REVIEWER COMMENTS

Reviewer #1 (Remarks to the Author):

In this work, authors have developed narrow band gap acceptor BTPV-4F with an optical bandgap of 1.21 eV, through the extension of double bond bridge of Y6 acceptor with one more vinyl group. Interestingly, the single-junction OSCs based on BTPV-4F as acceptor have achieved power conversion efficiency (PCE) of over 13.4%, with a high short-circuit current density (J_{sc}) of 28.87 mA cm⁻². Further, tandem devices were fabricated based on BTPV-4F:PC71BM: PTB7-Th rear cell, and PM6:carbazole acceptor m-DTC-2F as front cell, which reached a fairly high PCE of 16.4% with good photostability. Overall, this work contains a good set data covering both material chemistry and device engineering. It would be very suitable for attracting the readership of journals. Therefore, reviewer would like to recommend this work can be accepted for the publication in Nature communications, after some technique concerns being addressed.

Figure R1. Crystal structure of the SJ-IC.

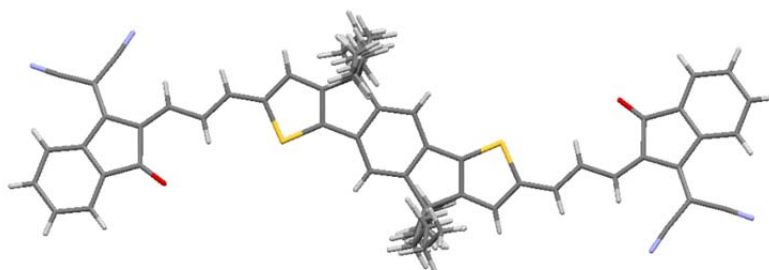
(1) The inserting of another ethylene double bond indeed broadens the absorption of NFAs, however, also introducing the high possibility for structural isomerism of molecules. Vinyl group is also liable to photoisomerization. Please verify the molecular structure of BTPV-4F in manuscript (scheme 1 and figure 1), also put NMR spectra into SI. it is important information.

In addition, our group had reported an acceptor called SJ-IC synthesized by inserting double bond to the IDT-IC (*J. Mater. Chem. A*, 2017, 5, 22588-22597) and we adopted the same synthetic route in this work. As shown in the following Figure R1, the single crystal structure of SJ-IC can also prove the *trans* form of introduced vinyl groups in the acceptor.

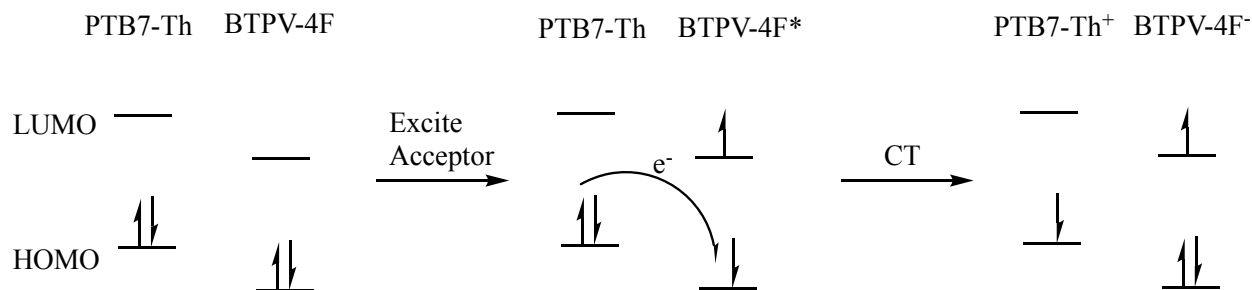
19. In the end I would like to come back to the discussion on which cell is now limiting more. The wide band gap cell has a voltage loss of 1.6-1.0 = 0.60 eV, the narrow band gap cell has a

voltage loss of $1.20-0.67 = 0.53$ eV. I think that at present the best OSCs have larger Voc losses for higher band gaps. This would actually argue that it is more important to develop wide bandgap sub cells than narrow band gap sub cells. A more detailed discussion on that could make this paper much more solid and important.

Response: We appreciate the review's comments and suggestion, and we agree that the wide bandgap materials are also very important to tandem OSCs. As shown in our response to Query 5, we added more discussions on this issue.

Our logic flow in constructing the tandem OSC in this work was based on the understanding of Shockley-Queisser limit in solar cells. We firstly focused on the development of narrow bandgap acceptor to purposely maximize the utilization of solar spectrum. In a certain combination of front and rear cell materials, narrow bandgap material usually affects the ultimate overall absorbing potential by determining the absorbing range. Subsequently, lowering the energy loss of those photons absorbed should be considered (especially for high energy photons), which is certainly more determined by wide bandgap cell. As discussed in the manuscript, future works should focus more on the development of wide bandgap materials to further boost the efficiency of tandem OSCs.
